Access Compliance Report

Public Rights-of-Way

Intersection ID: 30015	Main Street: MOORGATE_RD	Cross Street: YEARWOOD_LN	Location: NW
ADA ID: 0ED5ACAA2EB5	Ramp Type: PerpDiag	Initial Pass/Fail: Fail	Overall Compliance: No
		Severity Score: 12.5

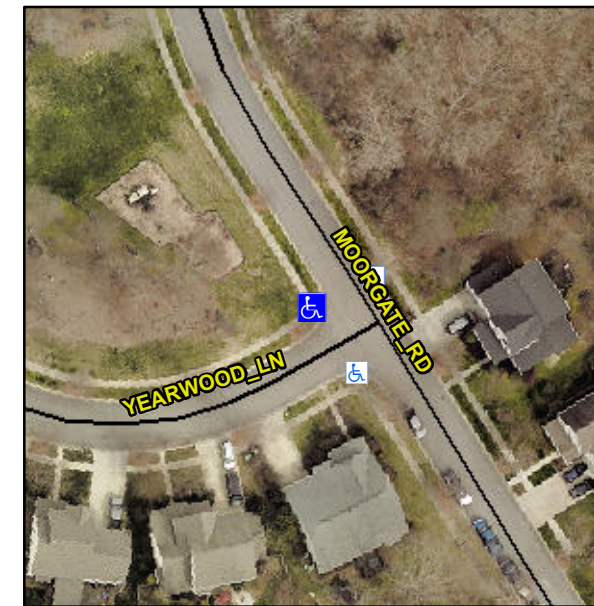
Not Found, R304.5.3

Compliance	Description	Data	Compliance	Description	Data
N/A	Ramp Length (in)	66.0	Yes	Ramp Slope (%)	6.2
Yes	Ramp Width (in)	48.0	No	Ramp XSlope (%)	5.5
N/A	Flare Type LT	N/A	N/A	Flare Type RT	N/A
N/A	Flare Slope LT (%)	N/A	N/A	Flare Slope RT (%)	N/A
N/A	Flare Traversable LT?	N/A	N/A	Flare Traversable RT?	N/A
N/A	Landing Length (in)	N/A	N/A	DWS Provided?	N/A
N/A	Landing Width (in)	N/A	N/A	DWS Contrast?	N/A
N/A	Landing Slope (%)	N/A	N/A	DWS Length (in)	N/A
N/A	Landing X Slope (%)	N/A	N/A	DWS Full Width?	N/A
N/A	Landing Curb? (Y/N)	N/A	N/A	DWS Offset (in)	N/A
N/A	Shared Landing?	N/A			
N/A	Gutter Ponding?	N/A	N/A	Gutter Slope (%)	N/A
N/A	Gutter Lip Ht (in)	N/A	N/A	Gutter X Slope (%)	N/A
N/A	Painted X Walk1?	No	N/A	Painted X Walk2?	No
	X Walk 1 Direction	To S		X Walk 2 Direction	To E
N/A	X Walk 1 Width (in)	N/A	N/A	X Walk 2 Width (in)	N/A
	X Walk 1 Slope (%)	0.4		X Walk 2 Slope (%)	4.2
	X Walk 1 X Slope (%)	3.0		X Walk 2 X Slope (%)	2.5

Remove & Replace Curb Ramp With Two New Directional Ramps or Equivalent.
